Comments on the January 2011 Revised Draft
Specification for Weather-Based Irrigation Controllers

May 19, 2011

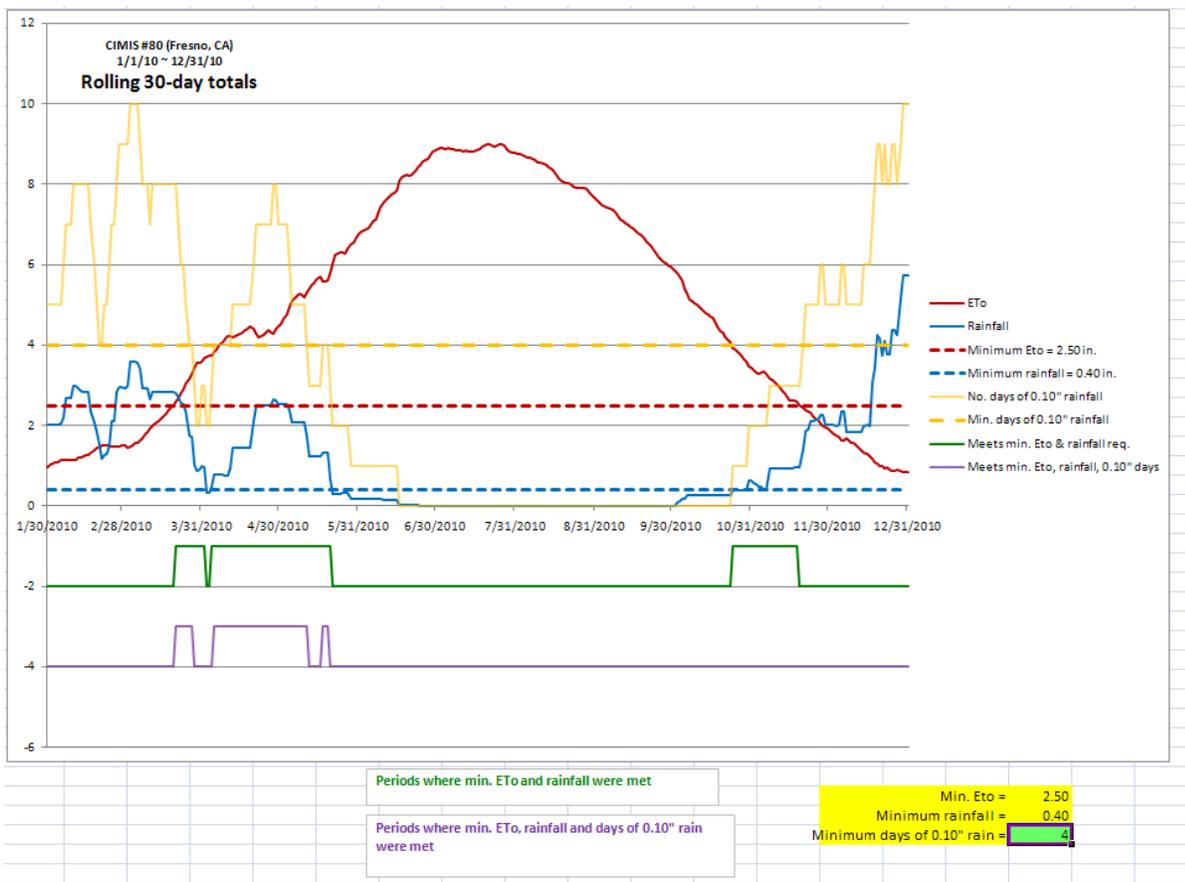
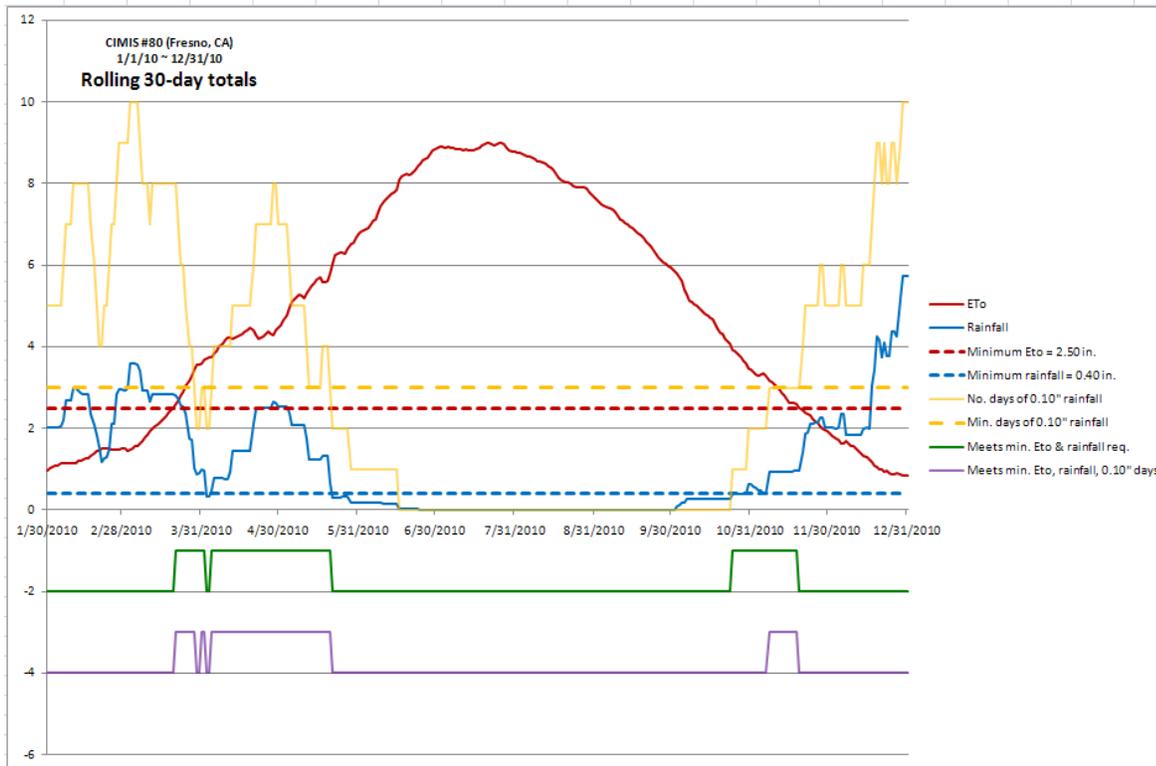
Comment: If the test is done in California (or other dry areas with little rainfall), this may be difficult to achieve.

Rationale: It's hard enough to meet the criteria with the current SWAT protocol. There's only about 2 periods out of the year where you can meet both the minimum requirements of $ET_0 = 2.50$ in. and rain = 0.40 in.. After crunching 2010 data from CIMIS Sta. #80, I found the additional 4-day requirement reduces the qualification period to only one period in the year (mid-Feb to mid-Apr) (see attached chart). If you reduce the requirement to 3 days, it opens up

another small opportunity in the fall. Another option is to extend test period to 60 days, and doubling the ETo and rainfall requirements to 5.00 inches and 0.80 inches, respectively.

Suggested Change (or Language): Keep the current 30-day requirements but reduce the requirement of 0.10 inch rain days from four to three.

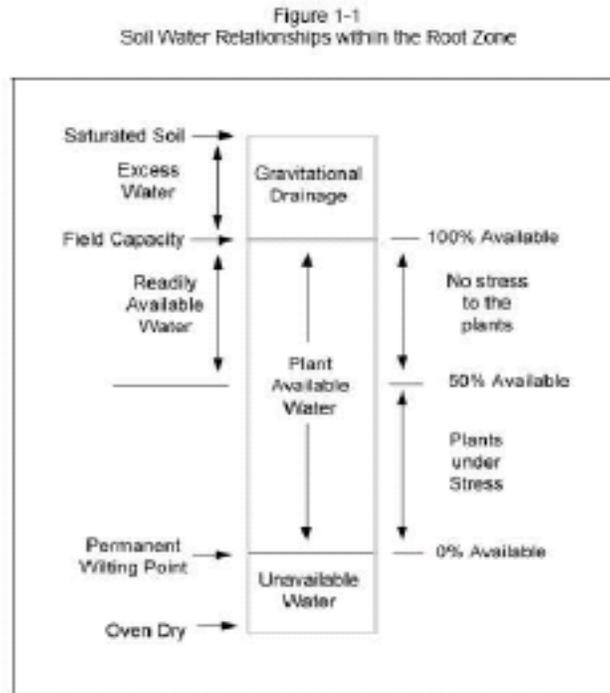
Comment: The report from the University of Florida had numerous references to affect of rain on test results. This new revised specification addressed some of the issues by changing the “Order of Operations” and the requirement for at least 4 rain events. But there is room for additional refinement in the test protocol. The soil moisture model that defines performance standard should more accurately reflect real-time conditions.

“RN = 0.8 (R), in. - Allows for an arbitrary loss of 20% of the rainfall to non-uniformity and runoff.”

The key word in this statement is “arbitrary”. Why should the EPA use an arbitrary value in this test when better science is available?

Suggested Change (or Language):

1) Change the Moisture Balance Spread Sheet calculations to an hourly time step. This means rainfall, ET and irrigation would be accounted for on an hourly basis. The model is far more accurate.
